CNL-23-015

Watts Bar Nuclear Plant, Units 1 and 2
Facility Operating Licenses Nos. NPF-90 and NPF-96
NRC Docket Nos. 50-390 and 50-391

Subject: Expedited Application to Modify the Watts Bar Nuclear Plant, Unit 1 and Unit 2 Technical Specifications for Main Control Room Chiller Completion Time Extension (WBN-TS-22-08)

Revised Figure 1 Temporary Non-Safety Related Chiller System

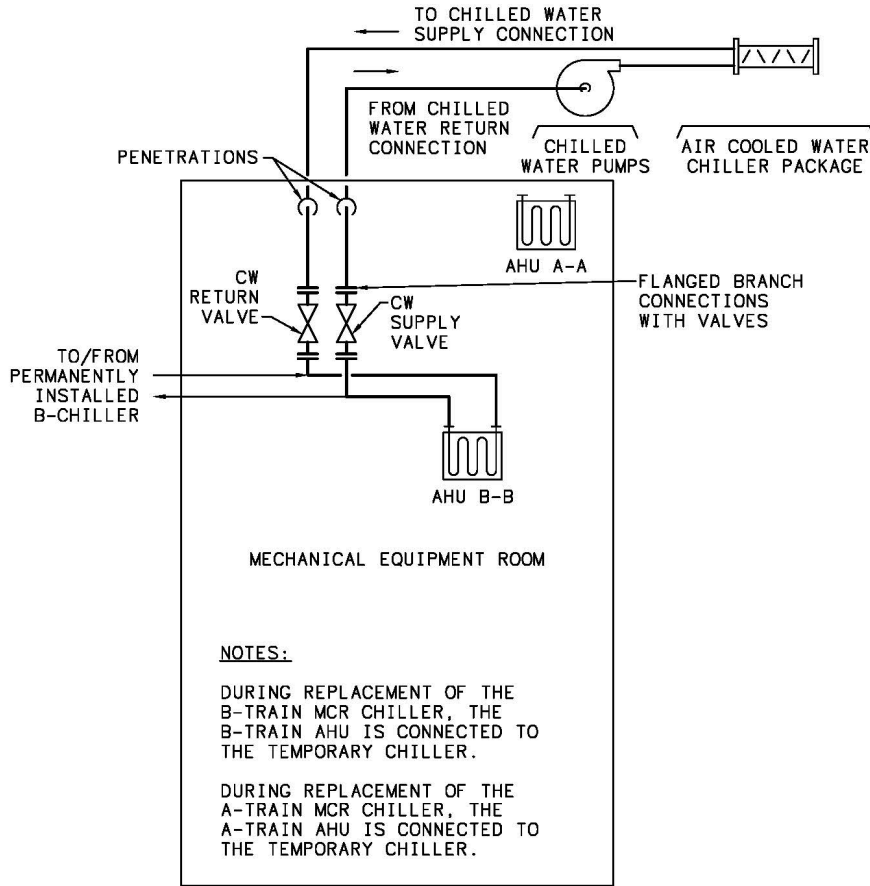
Differences between the currently planned MCR temporary chiller equipment description and the MCR temporary chiller equipment description in Section 3.1 to Reference 1 and the NRC Regulatory Audit Summary (Reference 4) are provided in Tables 2 and 3, respectively. Also, a revised Figure 1 provides an update to Figure 1 from Reference 1 regarding the Temporary Non-Safety Related Chiller System. There are no changes to the MCR temporary chiller equipment description in Reference 2.

Table 2				
Item No.	Description in LAR (Reference 1)	Currently Planned Installation	Reason for Change	Significance
1.	Page E6 of 24, paragraph 1 describes, "The chilled water piping inlet and outlet to the AHU is removed and replaced with temporary piping for the temporary chiller system."	Permanent modifications have installed branch connections on the air handling unit (AHU) inlet and outlet piping, eliminating the need to remove the piping at the AHUs. Each branch connection (a tee in the piping) includes an isolation valve and blind flange. The new branch connection piping, valve and blind flange meet the design requirements of the piping system. The installation of the branch connections does not adversely impact the conclusions of the moderate energy line break flooding study. When the temporary cooling equipment is to be removed, the isolation valve is closed and the blind flange is installed.	To allow more efficient (less time) transition between the temporary and permanent chillers which will be advantageous during the post modification test (PMT) window.	This new configuration is functionally equivalent to the configuration described in Reference 1 and is expected to benefit the project by reducing the time in the TS Required Action Completion Time.

Table 2				
Item No.	Description in LAR (Reference 1)	Currently Planned Installation	Reason for Change	Significance
2.	Page E6 of 24, Section 3.2 describes major equipment and includes “Chilled water Pump.”	The temporary chiller installation may have as many as three pumps. Additionally, one “major equipment” item that was not included in the Reference 1 description is a transfer switch, to allow transfer between plant power and the diesel generator (DG) for the temporary chiller.	The temporary chiller installation includes multiple pumps to meet necessary hydraulic conditions. The temporary chiller installation includes a transfer switch.	These items were included for completeness of information.

3.	Page E6 of 24, Section 3.2.1 refers to a 320kW DG. Section 3.2.4 also refers to the 320kW DG.	The DG referred to in Reference 1 (a rented Aggreko chiller) is rated at 320kW at 50Hz. The rating of the currently planned DG is 300kW at 60Hz, which is adequate for the temporary/rented Aggreko chiller equipment. A Caterpillar (CAT) generator and Carrier chiller have also been purchased by the site to reduce reliance on rented equipment. The ratings (tons and kW) of the CAT/Carrier equipment exceed the ratings of the rented Aggreko equipment.	Clarification on the rating of the Aggreko DG and also to include reference to the CAT generator which the site has purchased, along with a Carrier chiller.	Both the rented Aggreko equipment and the Carrier/CAT equipment have adequate electrical and cooling capacity to meet the requirements for the temporary chiller system.

Table 2				
Item No.	Description in LAR (Reference 1)	Currently Planned Installation	Reason for Change	Significance
4.	Page E6 of 24, Section 3.2.1, second paragraph states, "Connection to the AHU coils will be made by isolating the chilled water piping, removing the flex hoses between the AHU coils and the chilled water piping and then connecting the temporary chilled water supply and return hoses to the AHU coils using existing flange connections."	Permanent branch connections have been added to the AHU piping. Therefore, it is more accurate to state "Connection to the AHU coils is made via permanent flanged branch connections with an isolation valve," which were added as part of the chiller replacement project subsequent to the submittal of Reference 1.	To allow a more efficient (less time) transition between the temporary and permanent chillers, which will be advantageous during the PMT window.	This new configuration is functionally equivalent to the configuration described in Reference 1 and is expected to benefit the project by reducing the time in the TS Required Action Completion Time.

5.	Page E7 of 24, Section 3.2.2 refers to 2.5 inch (") diameter supply and return hoses.	Hose sizes used in the temporary chilled water system are of various sizes (3", 4" and 6").	Final configuration to meet hydraulic requirements.	Larger hose sizes meet hydraulic requirements and offer less resistance compared to smaller hose sizes.

6.	Page E7 of 24, Section 3.2.3 states, "The equipment associated with the temporary chiller system will be located in the yard west of the Auxiliary Building and in the Control Building (Elevation 729.0 feet)."	As noted in Reference 4, "The two potential locations with respect to assumed plant north are (a) due west of the Auxiliary Building or (b) northwest of the Unit 1 Containment."	Provide flexibility in chiller locations and align Reference 1 with Reference 4.	Both locations are a similar distance (hose run). Both locations are also sufficiently distant from the plant air intakes, which were reviewed by the NRC in Reference 4.

Table 2				
Item No.	Description in LAR (Reference 1)	Currently Planned Installation	Reason for Change	Significance
7.	Page E7 of 24, Section 3.2.3 states, "the temporary chiller system will be protected from freezing."	This statement is intended to mean "as required." The design package states that if the chiller is deployed during winter months, steps should be taken to avoid freezing (e.g., draining lines when not in use, use of heat tape and insulation).	Clarification.	Clarification.
